CITY OF ALBUQUERQUE

**RE: Universe View Apartments
Conceptual Grading & Drainage Plan
Engineer's Stamp Date: 07/31/23
Hydrology File: C09D016B**

Based upon the information provided in your submittal received 08/10/2023, the Conceptual Grading & Drainage Plan is preliminary approved for action by the Development Facilitation Team (DFT) on Site Plan for Building Permit.

TITLE: CONCEPTUAL GRADING & DRAINAGE PLAN

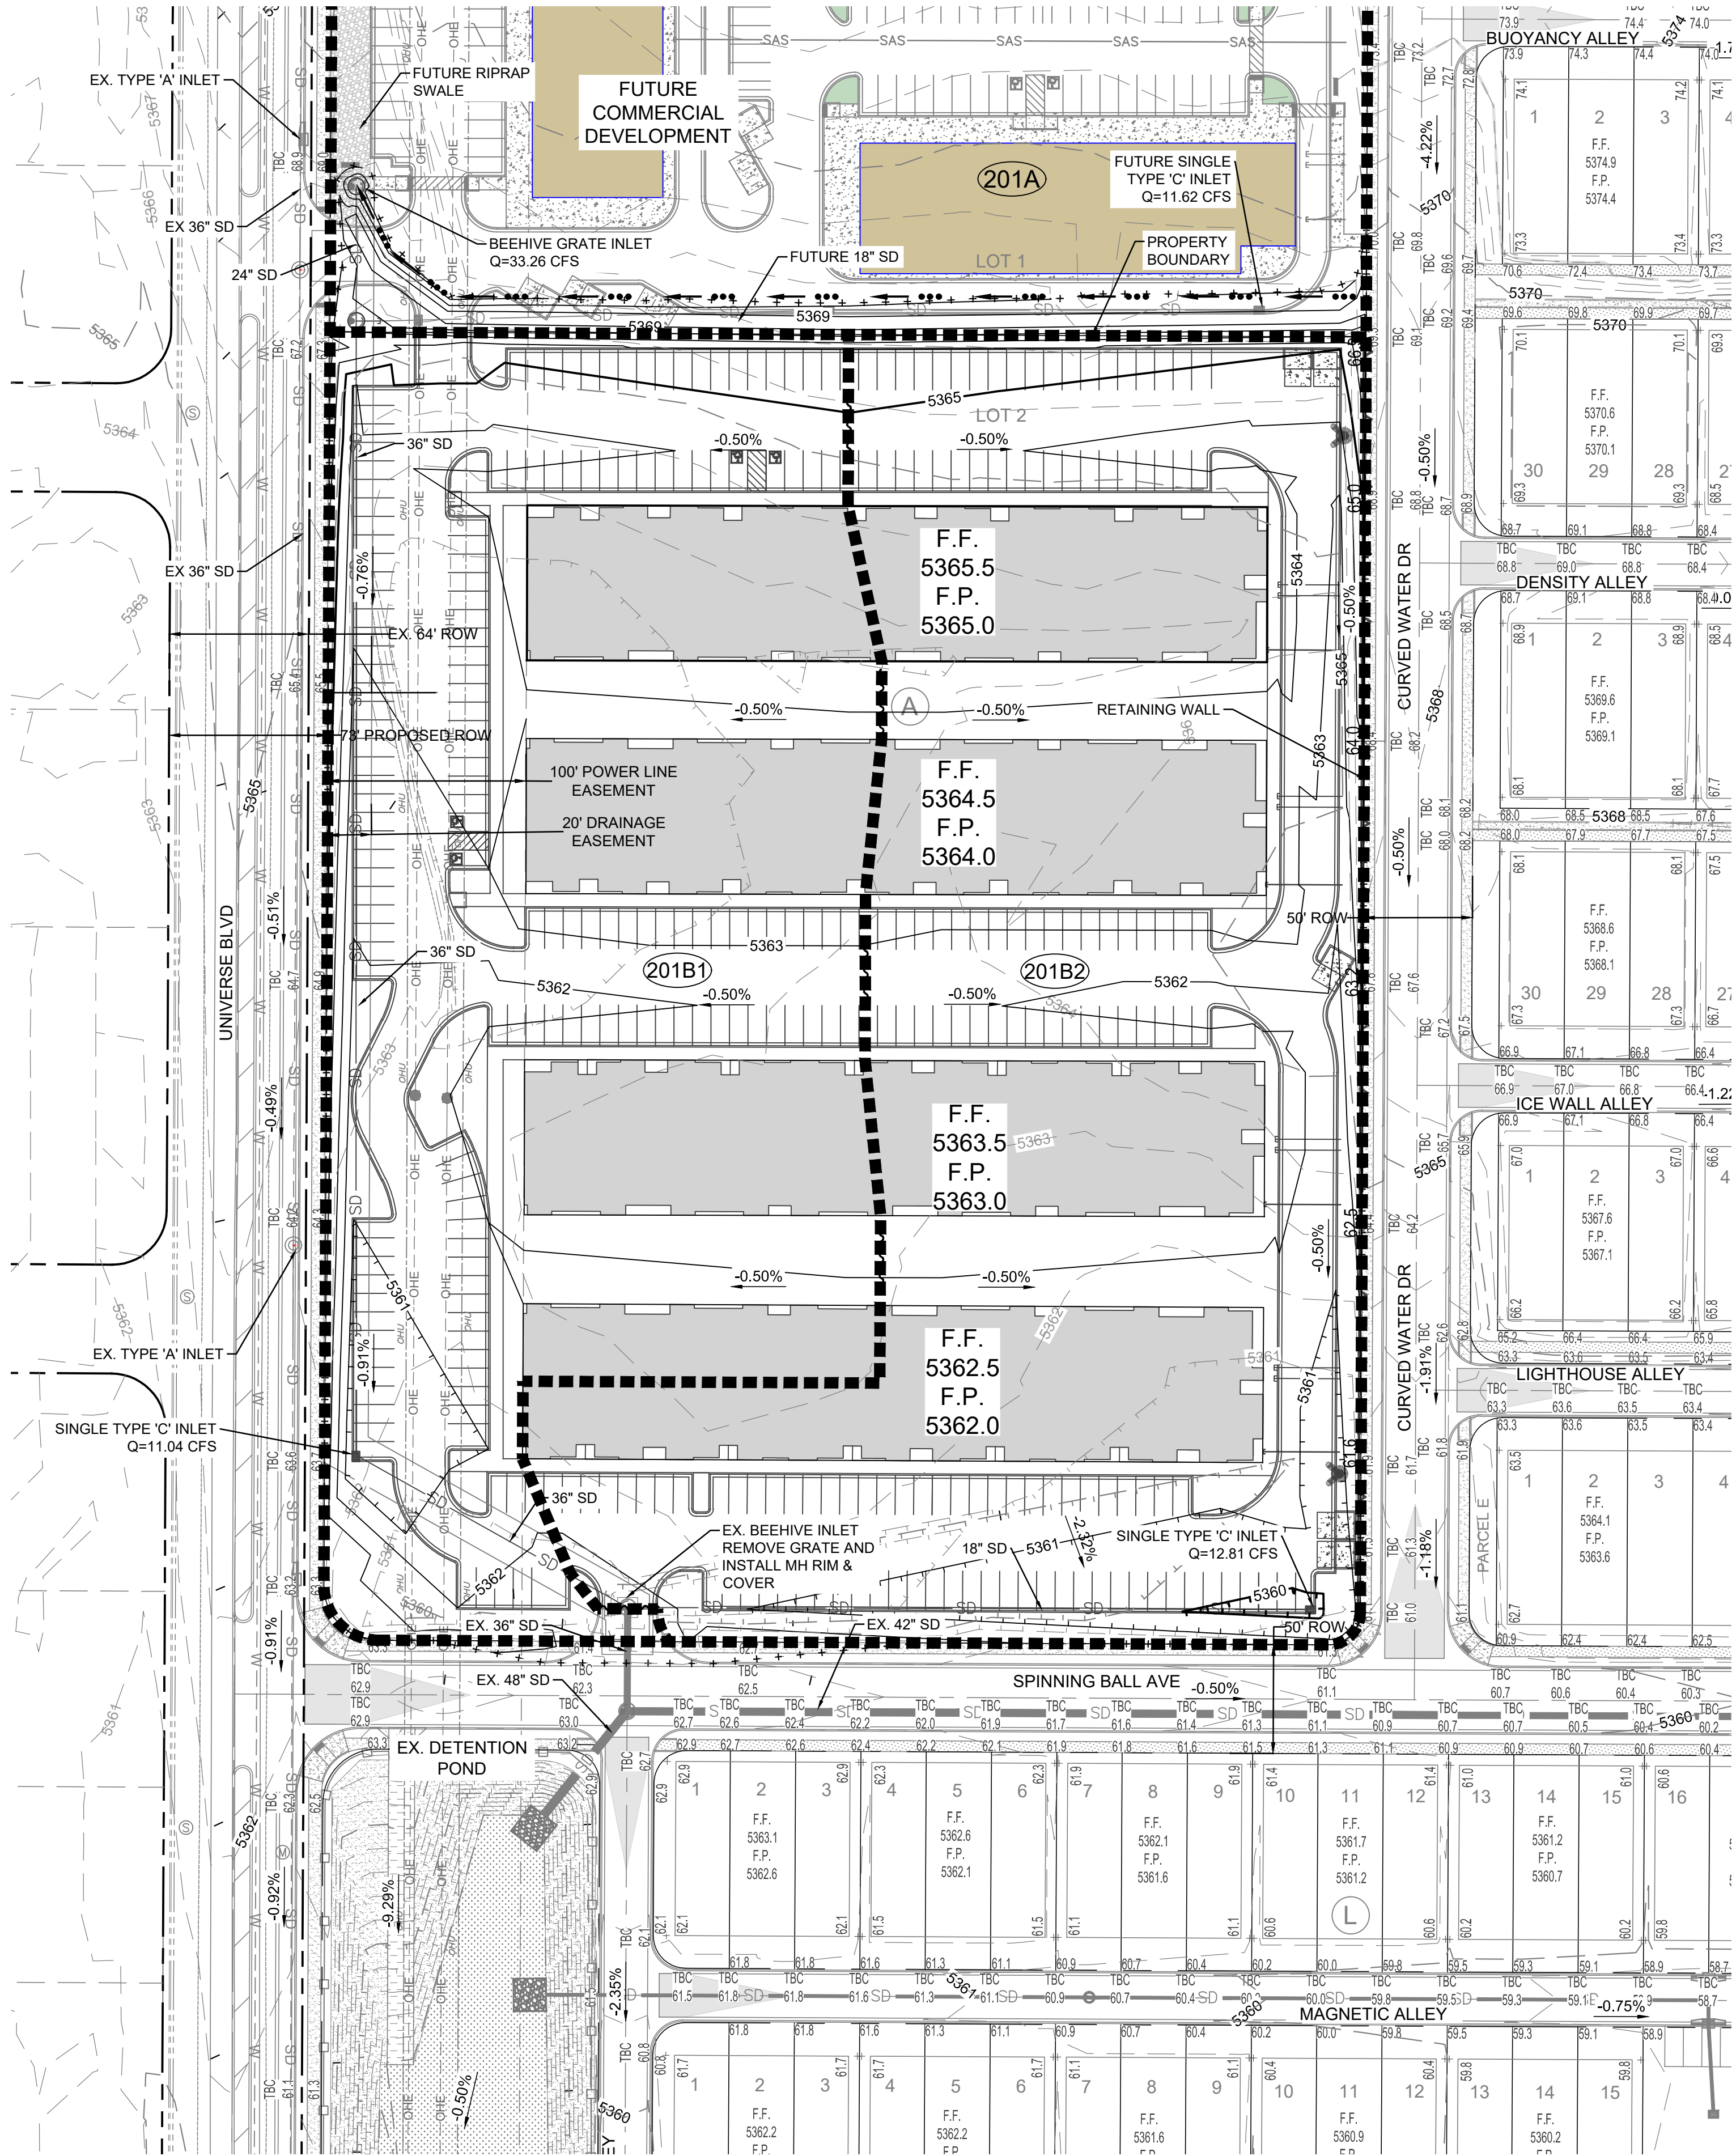
1. Please submit a more detailed Grading & Drainage Plan to Hydrology for review and approval. This digital (.pdf) is emailed to PLNDRS@cabq.gov along with the Drainage Transportation Information Sheet.
